Contract Addendum

Addendum No.: 2

Contract Name: WILDWOOD - Manchester Road Streetscape Phase 3
TWM Project No.: 140229

ROUTE: MO
STATE: MO
DISTRICT: SHEET NO. 60
COUNTY: ST. LOUIS
JOB NO.: STP-5536(610)
PROJECT NAME: MANCHESTER
SHEET NAME: SS
SHEET: 3 OF 3

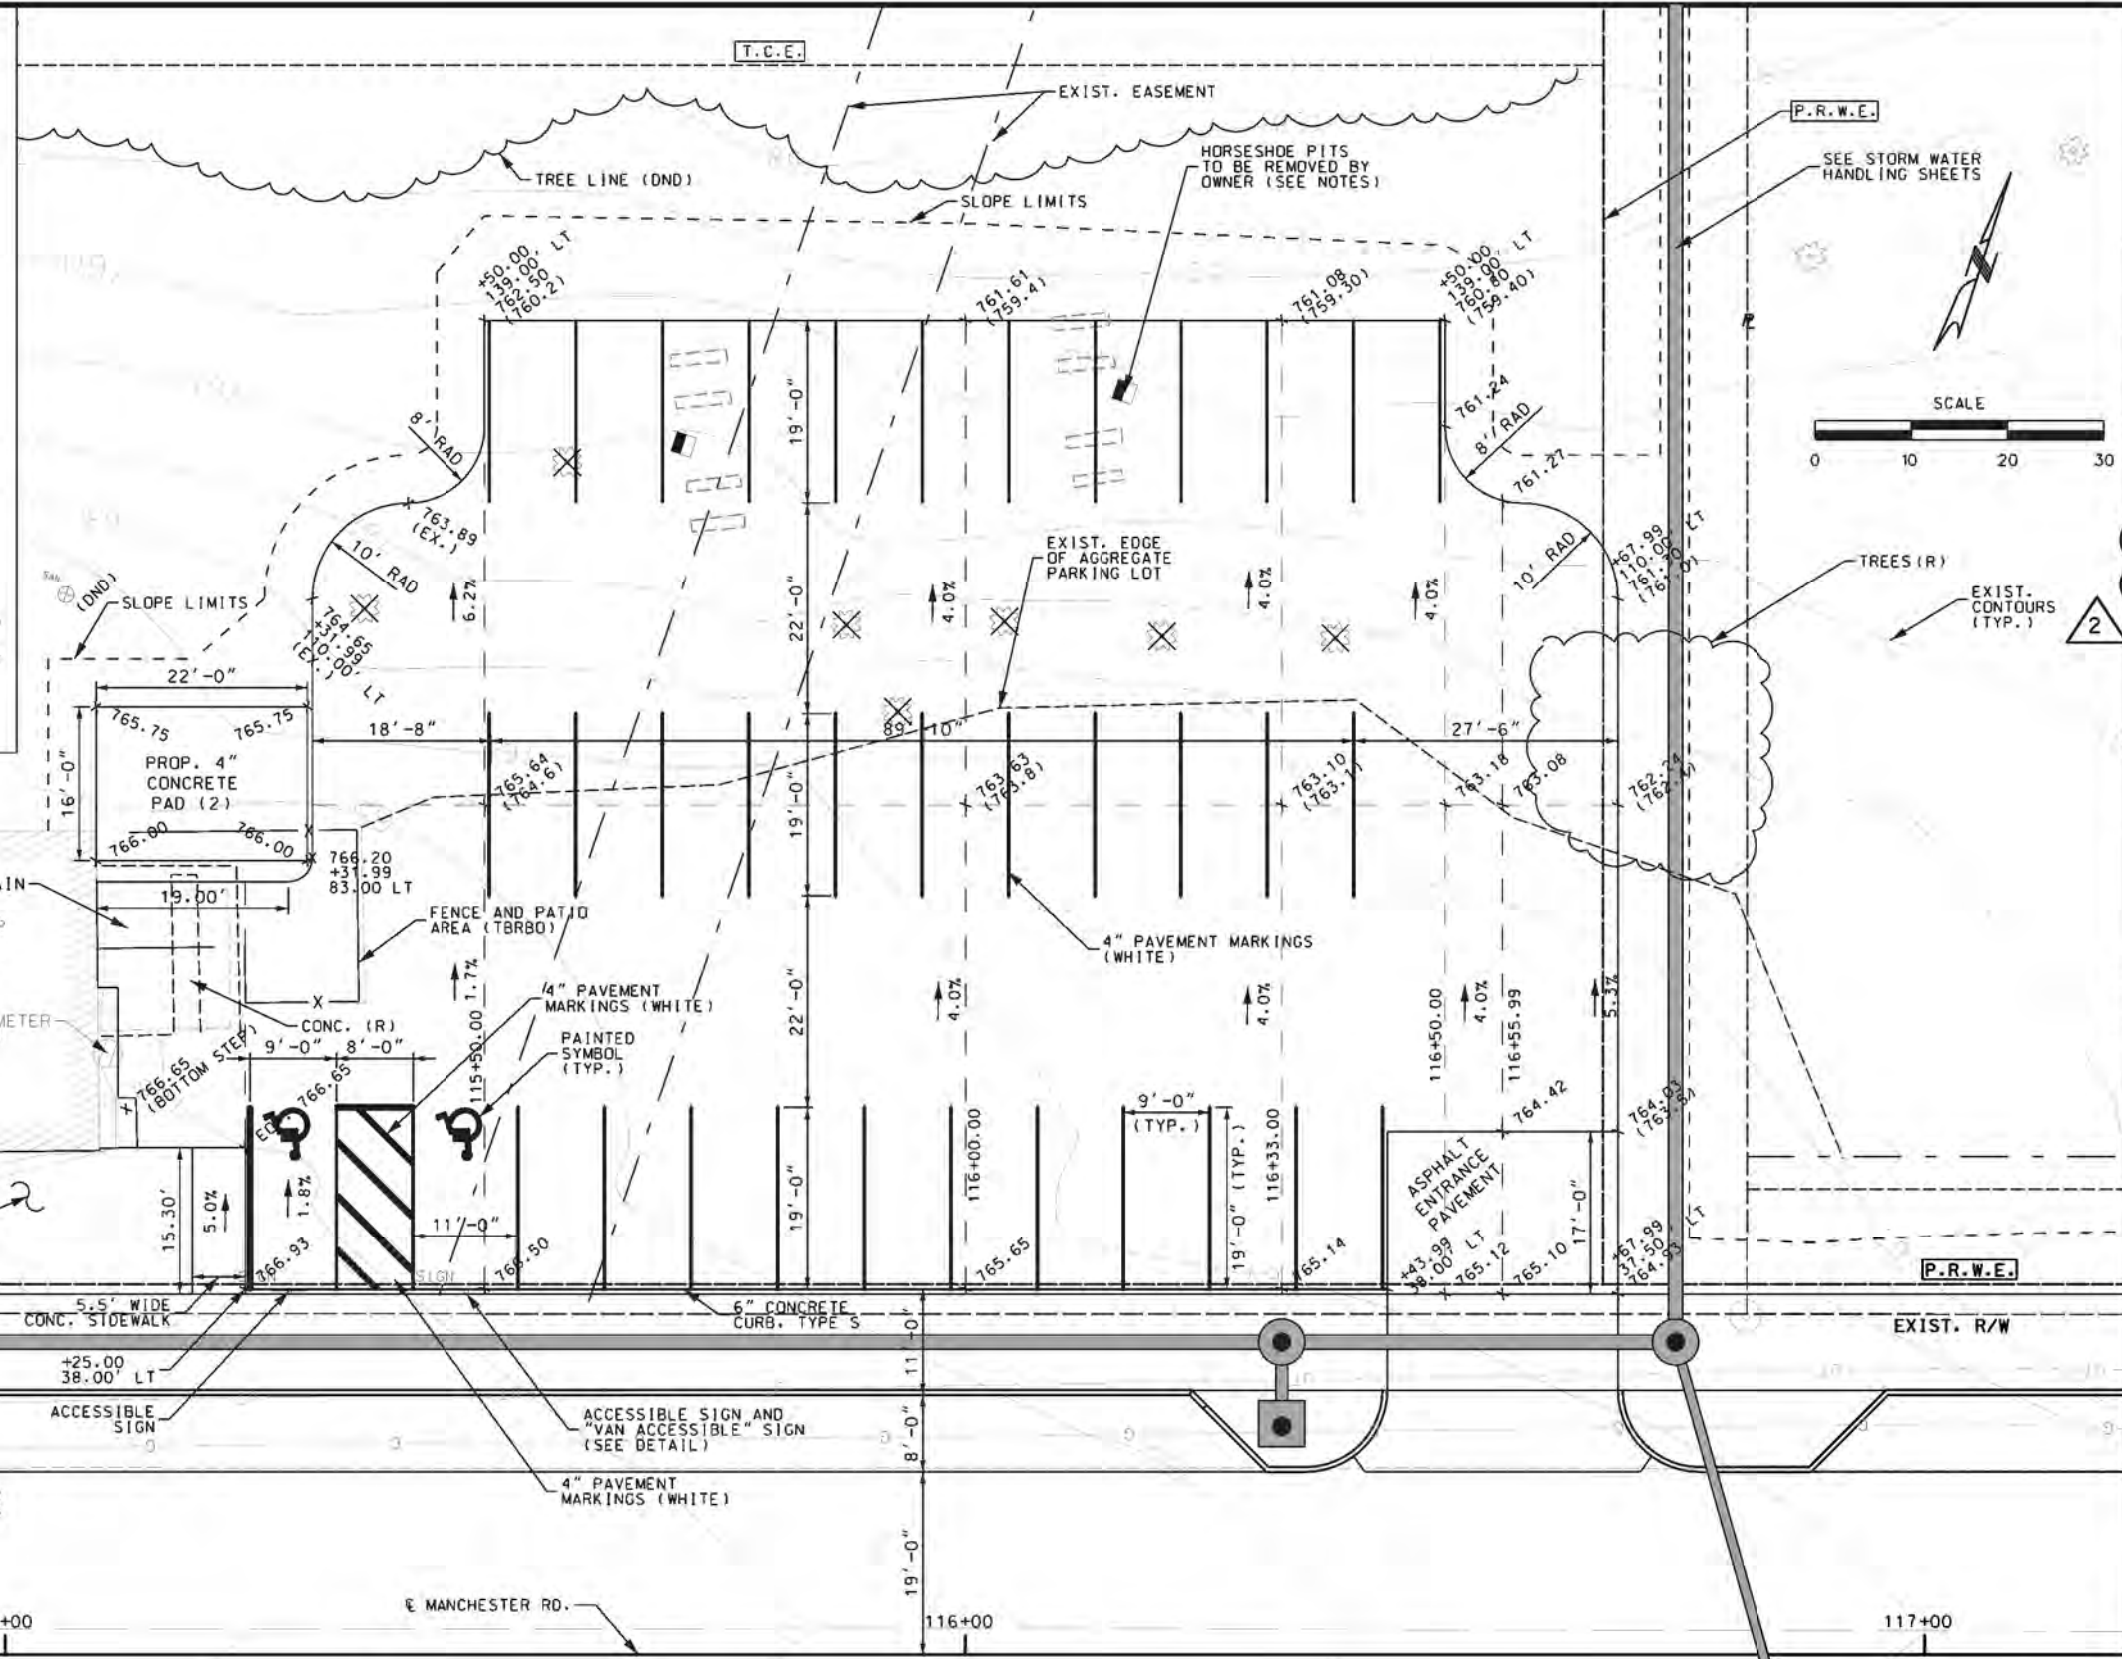
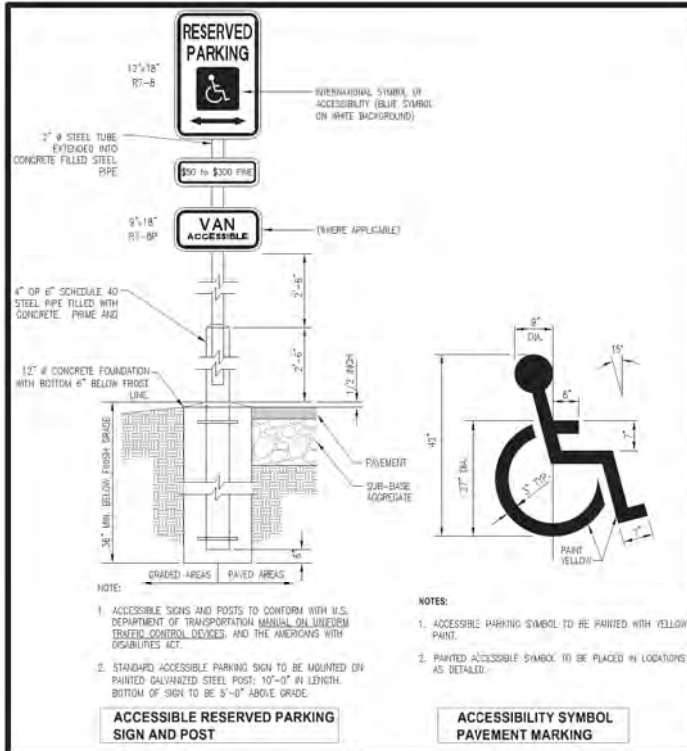
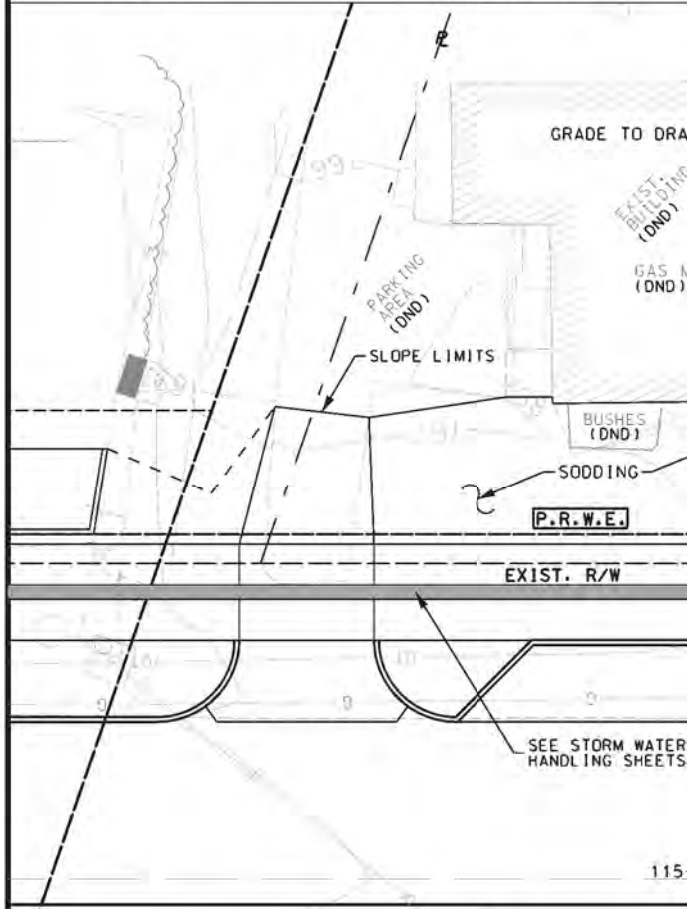
1. Revised - Pay Item "MISC., SIGN ON PRIVATE PROPERTY" Removed. See Quantity (QU) Sheet 1 of 18 and. See Revised Bid Sheets.
2. Revised - Sheet name changed to "SS" and Sheet number changed to "3 of 3". See Special Plan Sheet 60 (SS 3 of 3).

DESCRIPTION: SHEET NAME AND # S
